Technical Memorandum

To: EPA Region 4 and Georgia EPD
From: Kirk Kessler, on behalf of the LCP Site Steering Committee
Subject: Response to Comments on *Site Characterization Summary Report Operable Unit 2 (OU2) Groundwater and Cell Building Area for the LCP Chemicals Site, Brunswick, Georgia, Dated February 2020*
Date: May 26, 2020

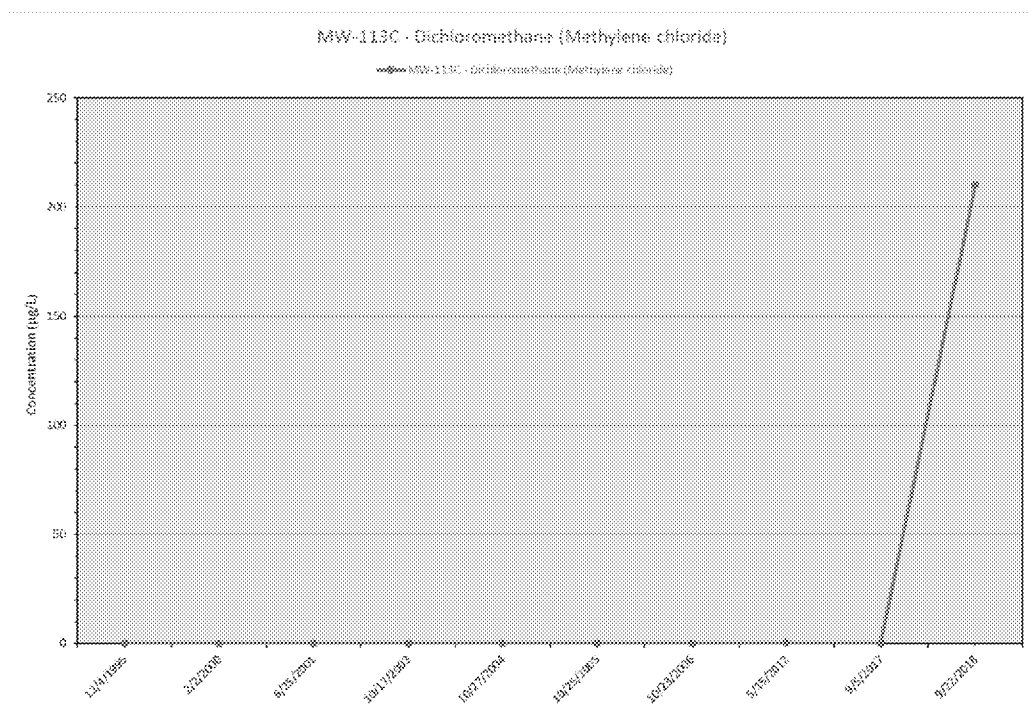
11. Dichloromethane: *High concentration (213 - >MCL) detected at MW-113C in 2018, no upgradient delineation. EPA requests that the data gap be addressed by the next sampling event.*

Dichloromethane (Methylene Chloride) is a well-known laboratory cross-contaminant. See the graph below for the time series monitoring record for Dichloromethane at well MW-113C where it is apparent the 2018 measurement is a data anomaly that can be attributed to laboratory contamination.

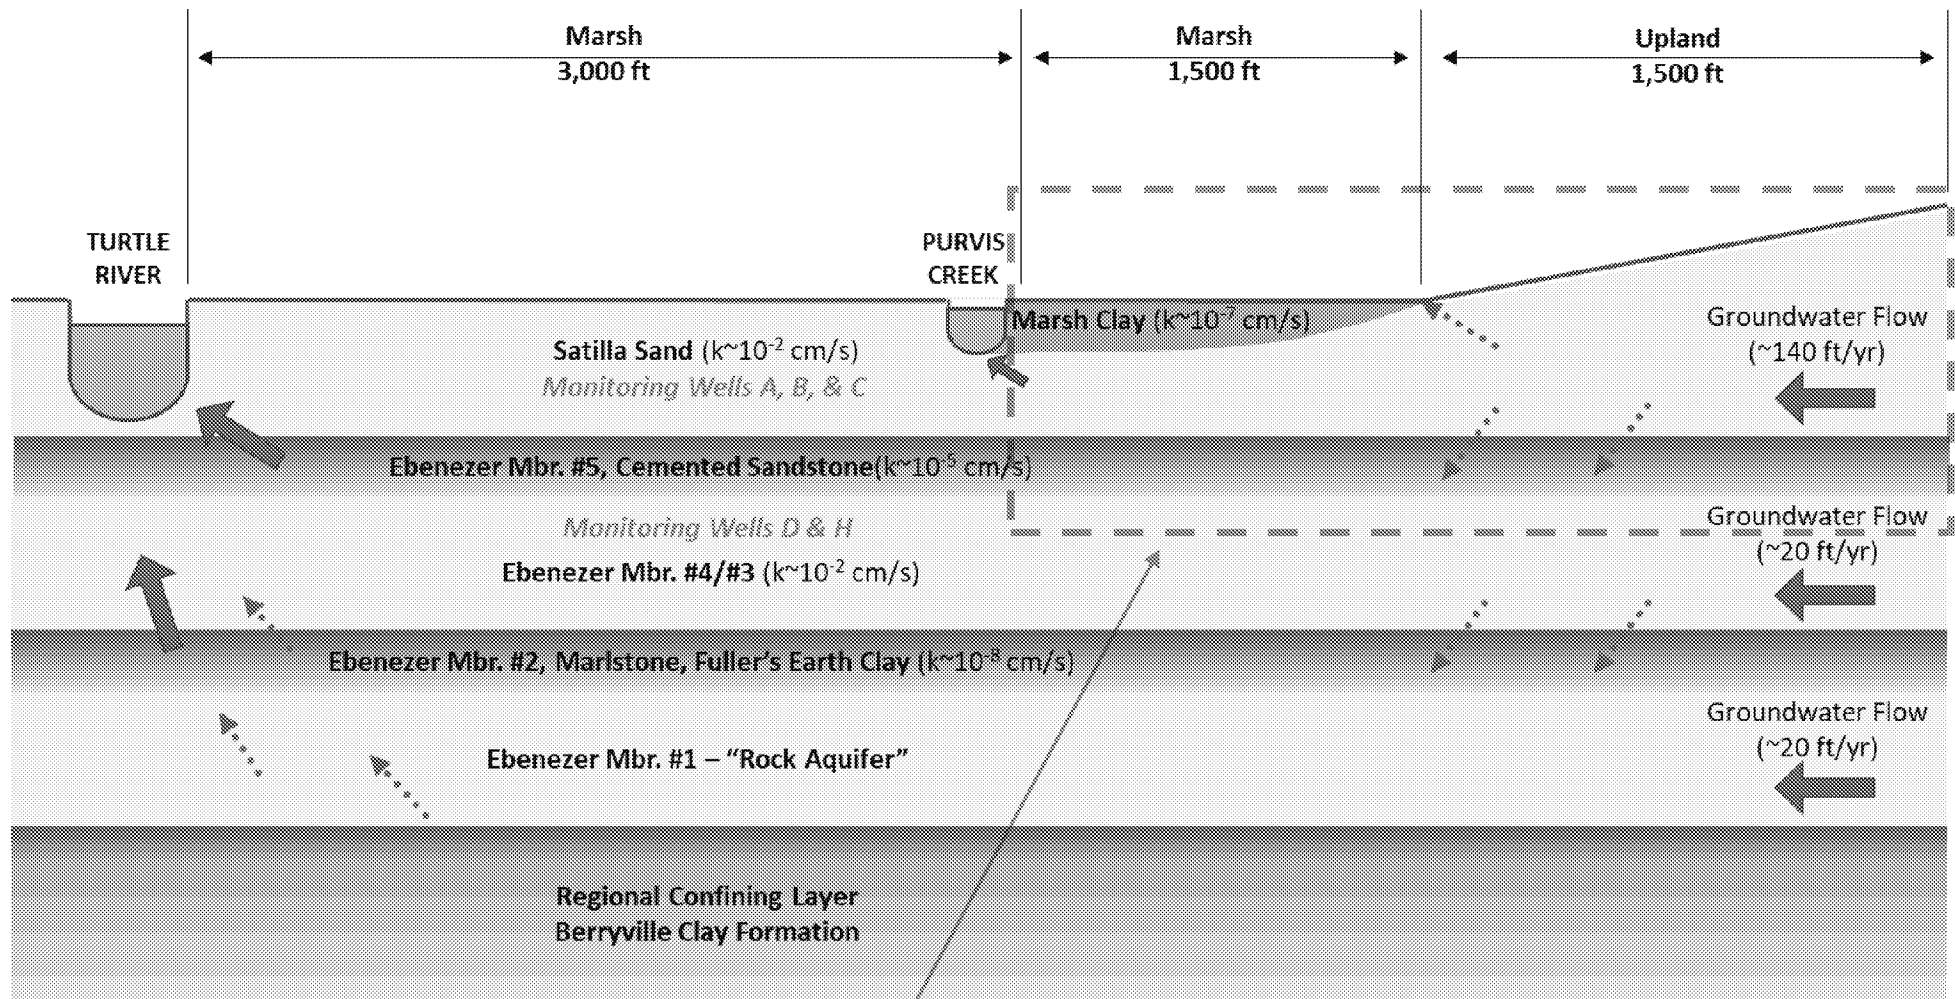
20) Appendix B – Groundwater Data Trend Viewer – numerical values are not shown for some constituents (i.e. Arsenic Figures). Some constituents show an increasing trend in values and/or have a limited number of data points. For example, MW-362B for mercury has 3 data points, the last sample occurring on 9/11/2019 at a value of 21.1 ug/L. Increasing trends in pH are observed in some wells such as MW-101D, MW-115D, MW-301B, MW-361B, some which have values approaching or over 10.5.

The inconsistencies in labeling of numerical values is a quirk within Excel (graphs are not intended to also post numerical values) that cannot be fixed.

Please note that wells MW-361A,B and MW-362A,B were only installed in 2019, as part of the Phase 4 CBP response.

The reviewer can consult the revised viewer (which provides normalized concentration axis worksheets) regarding interpretation of temporal trends. Trend evaluation will be part of the OU2 RI Report.
